Environmental Review Team Report

Cherenzia Property

North Stonington, Connecticut

August 1984

Drainage Areas

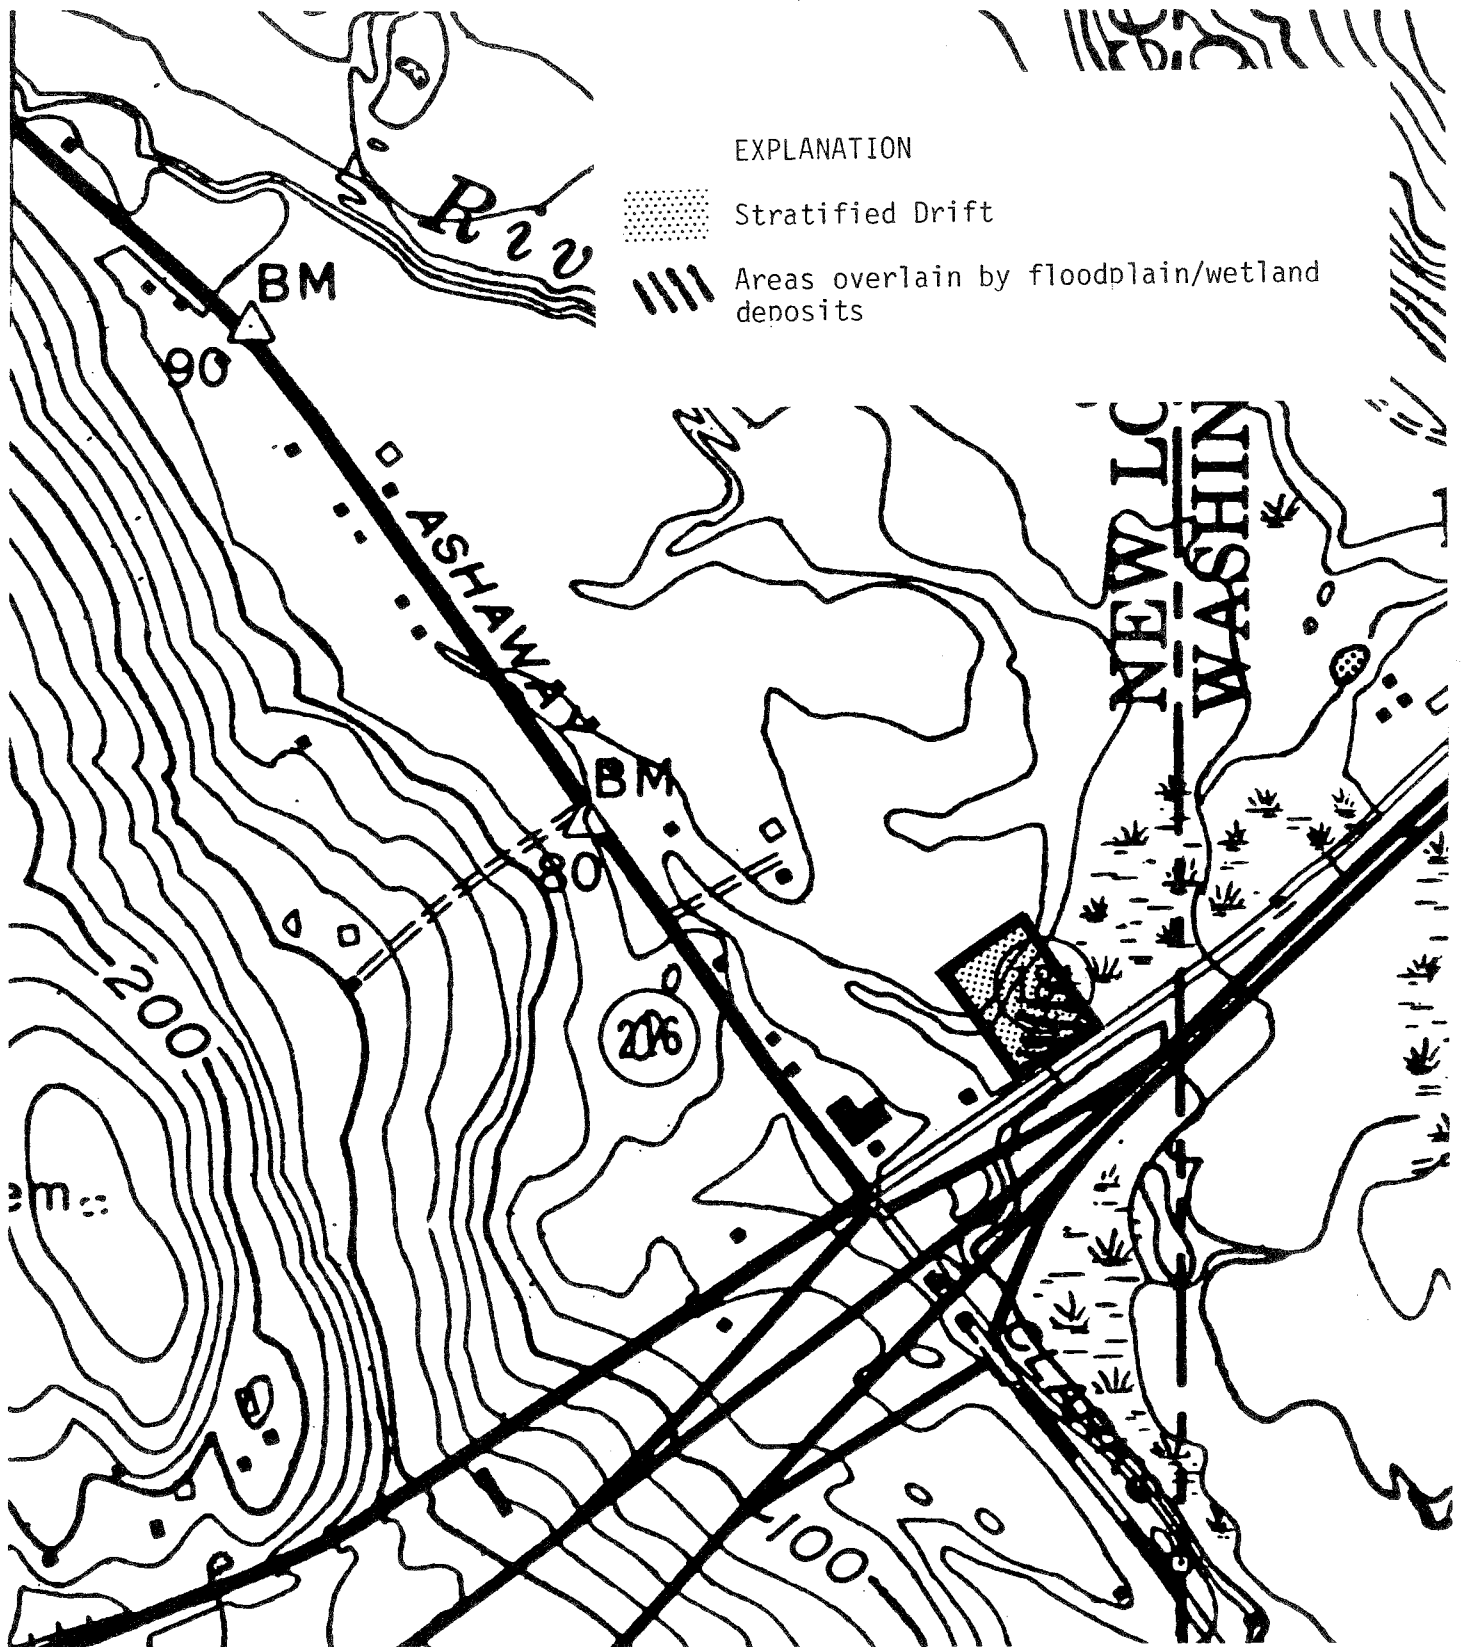
Development of the site is expected to cause an increase in the runoff flows from the site. These increases will arise mainly from the creation of impermeable surfaces such as rooftops and paved driveways and parking areas over highly permeable soils. According to the project engineer, at least one acre of the site would be covered with impermeable surfaces.

It is possible to estimate the post development runoff depths for storms of various magnitudes (e.g., 10-year, 24-hour storm, etc.) by using simplification of a method outlined in Technical Release No. 55, published by the Soil Conservation Service, U.S. Department of Agriculture. The method involves the determination of runoff curve numbers for a given watershed. These numbers relate runoff to rainfall in the watershed on the basis of soil types and current and proposed land usage. For the purposes of analyzing the runoff depths likely to occur under the present proposal, a design point and its corresponding watershed was chosen (See Drainage Area Map.). The watershed shown is based upon a particular design point and delineates all the land from which surface runoff ultimately reaches that point. It should be pointed out, however, the project engineer may use other acceptable methods (i.e., rational method) available to him for calculating runoff changes.

The results of the Team geologist's calculations, shown below, for the design point chosen, should be considered "ball park" figures with regard to runoff volumes. The calculated percentages of increase should be fairly close, however.

Runoff depth increases under the present proposal are as follows:

10-year 24-hr. storm	25-year 24-hr. storm	50-year 24-hr. storm	100-year 24-hr. storm
Before Development	.75	1.05	1.3	1.7
After Development	1.51	1.97	2.39	2.98
Percent Increase	101%	88%	84%	75%

These increases are significant and underscore the need for judicious storm-water management on the site. Under present plans, the applicant wishes to fill in ±1.0 acres of the wetland which presently provides natural runoff retention. By filling in the wetland, the valuable storage capacity of water in the wetland will be reduced, forcing the excess water to flow downstream sooner than it otherwise would.

It is recommended the applicant be required to submit detailed hydrological information on pre- and post-development runoff volumes and peak flows from the site once the use of the site has been determined. For example, if the property was developed creating only a small area of impervious surfaces, the runoff depths may not be as significant as those shown in the table. As a result, there may

be less of an impact on the wetlands and ultimately downstream areas. Estimates should be provided for a 10, 25, 50 and 100-year design storm. Detailed design specification for all stormwater control facilities should also be submitted. The project engineer should take a close look at downstream culverts to determine if they can handle post development flows from the site.
